**Re: Response to Comments Letter
McDonald's Restaurant
413 Main Street
Reading, MA**

Please find below our responses to Planning Division comments provided via email from Mary Benedetto, Senior Planner, on August 23, 2023 and a Memo provided by the Town of Reading Engineering Division dated August 31, 2023. For clarity, the comments are in italics, while our responses are directly below in normal font. This response letter references plans by Bohler Engineering revised through 8/15/2023.

Planning Division comments via email dated August 23rd, 2023

STATUS	DATE	BY
DRAWN BY:	04/28/2023	CSE
PLAN CHECKED	-	-
AS-BUILT	-	-
SHEET NO.	C-301	
	OF 15

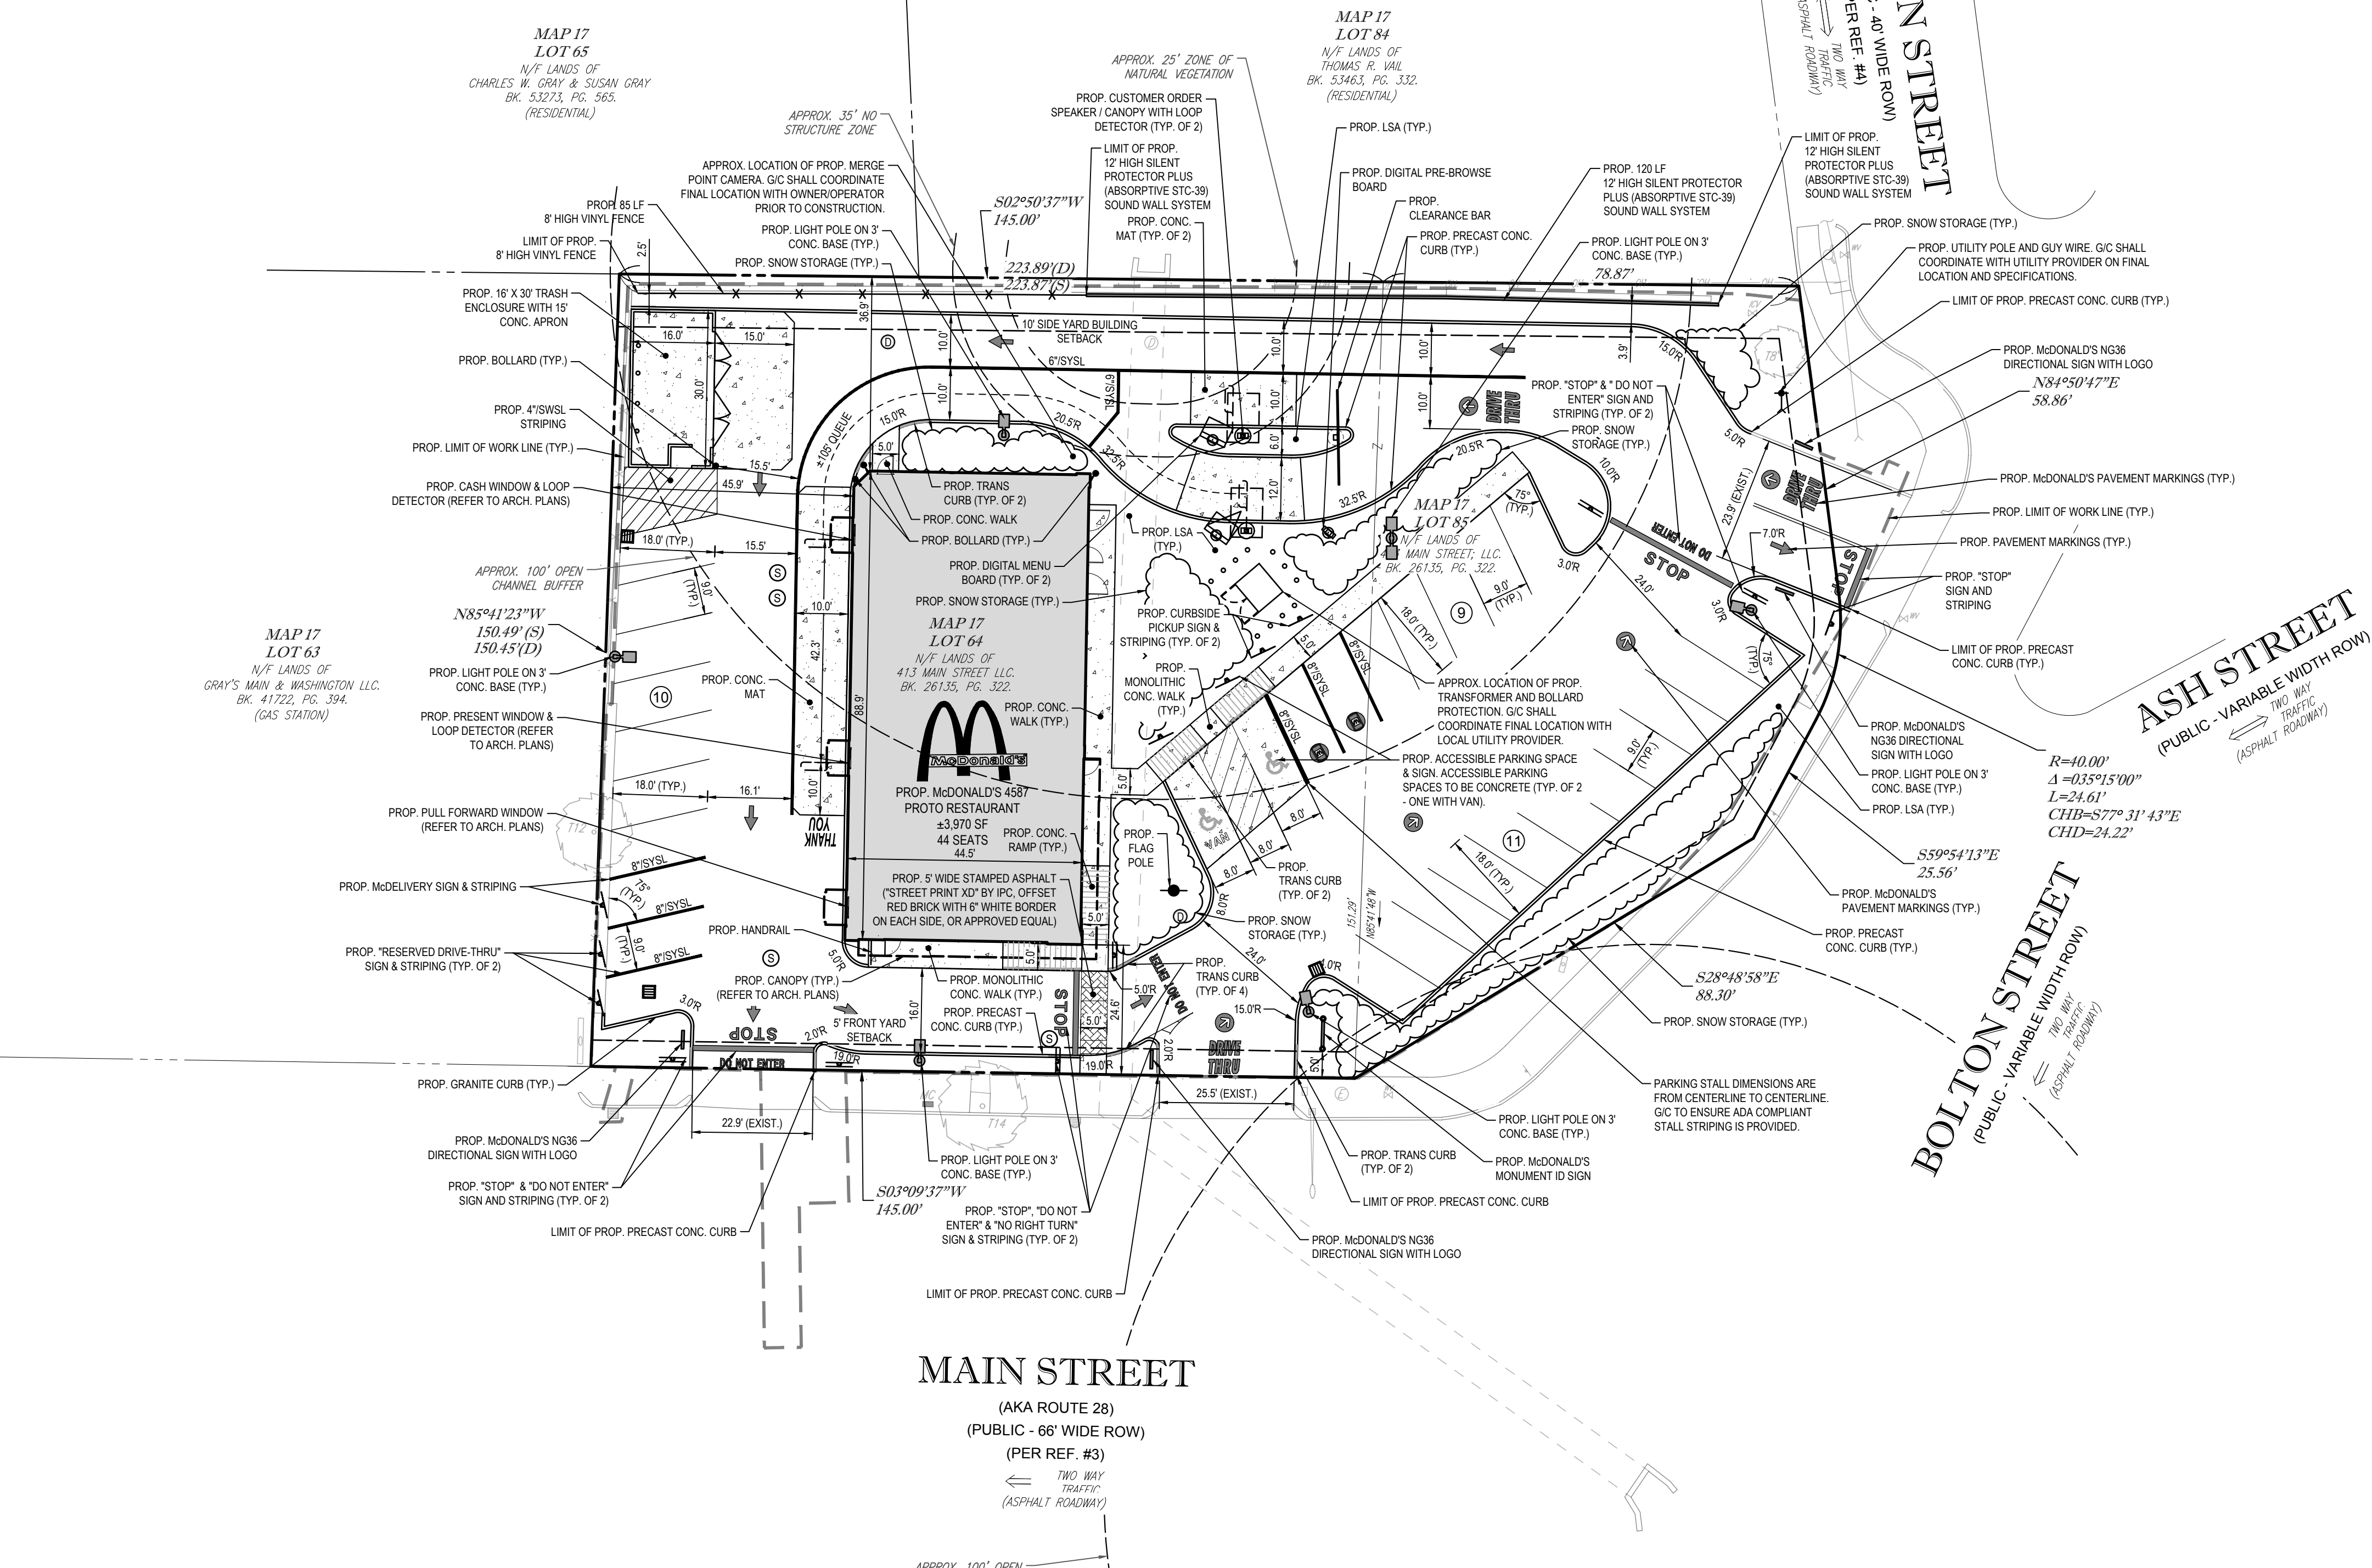
Comment 2: *Parking: Please include the parking calculation information for the 32 new spaces proposed. How many seats are proposed inside the restaurant and what will be a max employee count?*

Comment 3: ***Drive-thru stacking capacity:** Please provide the total lane stacking capability in feet of both the existing drive-thru and the new proposed dual order point. Our bylaw requires 198ft in length, of which at least 90ft are for ordering and transacting, and at least 54ft stacking capacity exiting onto the road.*

Comment 3: *Thought should be given to the placement of the crosswalk in front of the building to provide better protection to pedestrians. The stop bar is after the crosswalk allowing vehicles to stop on the crosswalk, the stop bar and/or crosswalk should be relocated.*

Response 2: Parking calculations have been provided in the Zoning Analysis Table on Sheet C-301 of the "Proposed Site Plan Documents". 44 Seats are proposed within the restaurant and the max employee count is 12 employees. Based on the required parking for a restaurant use (1 space per 4 seats plus 1 space per employee on the max shift), the minimum required parking is calculated as 23 spaces. 30 parking spaces are proposed as part of the redevelopment project and is reflected in the cover letter, project narrative, and plans accordingly.

Response 3: The total lane stacking capacity for the existing drive-thru is 105 FT (approx. 6 vehicles) from the present window to the order point, and 137 FT (approx. 8 vehicles) from the order point to drive-thru lane entrance at the Main Street ROW. The distance between the existing present window and the exit drive is 55.2 FT.

Under proposed conditions, the stacking capacity for the side-by-side drive-thru layout is to be 187 FT (approx. 10 vehicles) from the present window to the order points and 108 FT (approx. 6 vehicles) from the order points to the drive-thru lane entrance. It is notable there is an additional 225 LF of stacking to the Bolton Street and Main Street ROW (approx. 10 vehicles). The distance between the proposed present window exit and the roadway is 58.4 FT. The zoning analysis table on sheet C-301 has been updated with this information and existing and proposed drive-thru stacking exhibits have also been included as part of this resubmittal.

Response 3: The crosswalk location has been proposed in order to provide an accessible connection from the public sidewalk as required by ADA/AAB regulations and also the furthest point away from vehicles making the turn into the recirculation lane. The plans have been revised to relocate the stop bar and signage before the pedestrian crosswalk and the crosswalk will be treated with red stamped asphalt in contrast to the asphalt surface for improved visibility. A "Pedestrian Warning" for vehicles is also now proposed prior to the crosswalk. Please refer to Sheet C-301 of the "Proposed Site Plan Documents".

PLAN APPROVALS	SIGNATURE	DATE
APPROVED MCDONALD'S AGENT		
STATUS	DATE	BY
DRAWN BY:	04/28/2023	CSE
PLAN CHECKED	-	-
AS-BUILT	-	-
SHEET NO.	C-401	
	OF 15

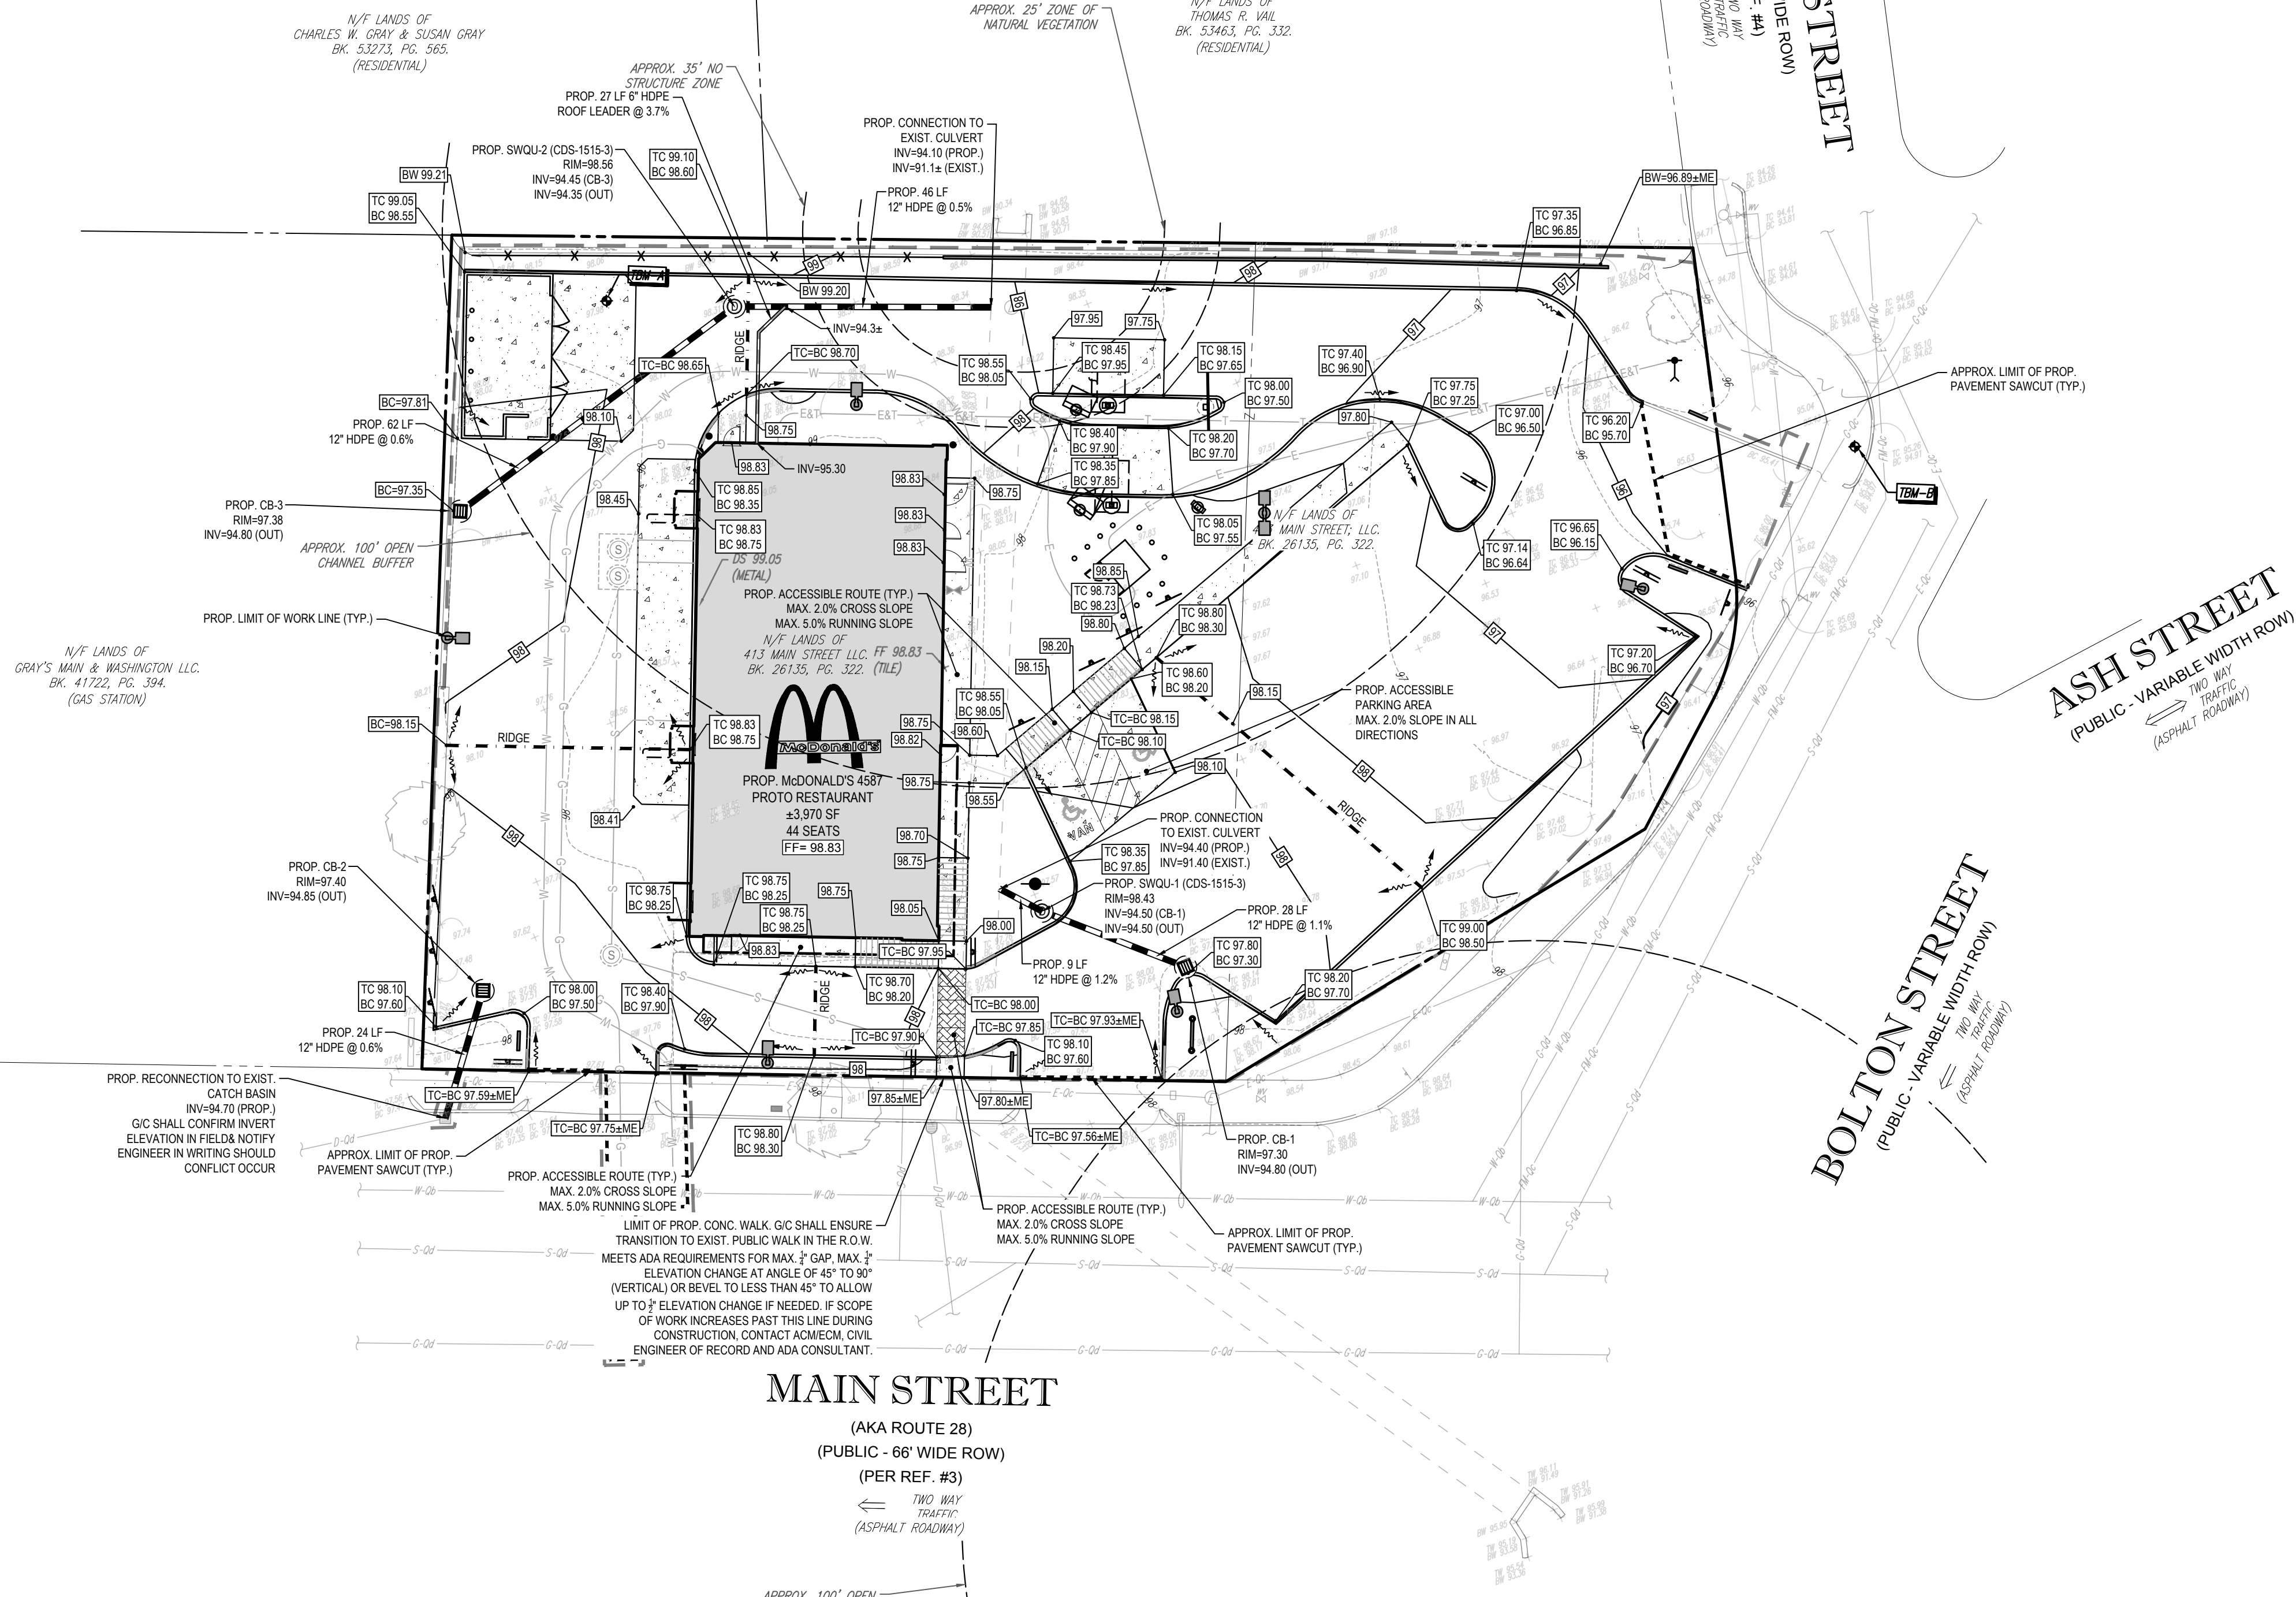
Comment 10: ***Drainage:** We’ll defer to the Town Engineer for forthcoming detailed comments, but unless I missed it I do not see the pre-treatment infrastructure noted on the plan sheet?*

Comment 8: *The size and type of all existing and proposed utilities shall be labeled on the plan.*

Response 10: Two (2) stormwater quality pre-treatment units (CDS-1515-3) are proposed along each of the two drainage lines prior to discharge of stormwater into the underground culvert. Labels have been updated to “SWQU-1/2” on sheet C-401 for clarity.

Response 8: Size and type of all available existing utility information and proposed have been labeled on the plan. Please refer to Sheet C-401 and C-501 of the "Proposed Site Plan Documents" for additional information.
